From: dustin@dmroma.com
Sent: Monday, June 8, 2020 12:32 PM
To: Mark T. Arienti; 'Jayson Haskell'
Cc: Jennifer Curtis
Subject: RE: Depot Street Final - Completeness Review
Attachments: Hydrocad - Depot St - 25yr POST.pdf; Bike Rack Detail.pdf; 04 - Site Plan.pdf; Grade Comparison.pdf; 464803-WI-~6DepotSt-Ability to Serve Determination.pdf; 03 - Subdivision Plan.pdf; Light Fixture Cut Sheet.pdf

I reviewed the MCL Realty Depot Street Residential Development Final Plan set dated 5/8/20 as well as the comments and response prepared by the Maine DEP for their review of DM Roma's Stormwater Permit Application including their 4/28/20 Stormwater Management Report, response to DEP comments dated 5/8/20 and the response to their submittals by Aubrey Strause, Maine DEP Stormwater Engineer in a memorandum dated 5/8/20.

SUBDIVISION PLAN
DEPOT STREET RESIDENTIAL DEVELOPMENT
DEPOT STREET
WINDHAM, MAINE
FOR RECORD OWNER:
MCL REALTY, LLC
PO BOX 1206
WINDHAM, ME 04092

BIKE RACK SPECIFICATION

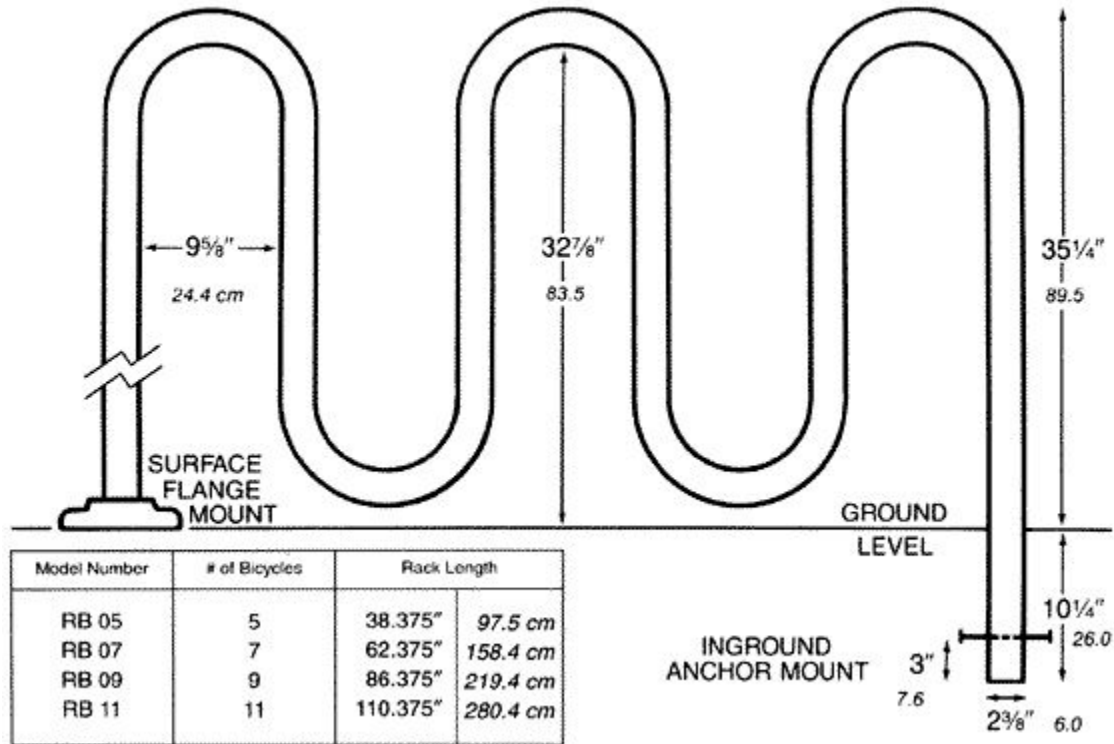
- The location(s) and a detail for bike racks should be shown on the plans. **Attached is a bike rack detail. Also attached is a revised Site Plan showing the three locations of proposed bike racks, one for each building.**
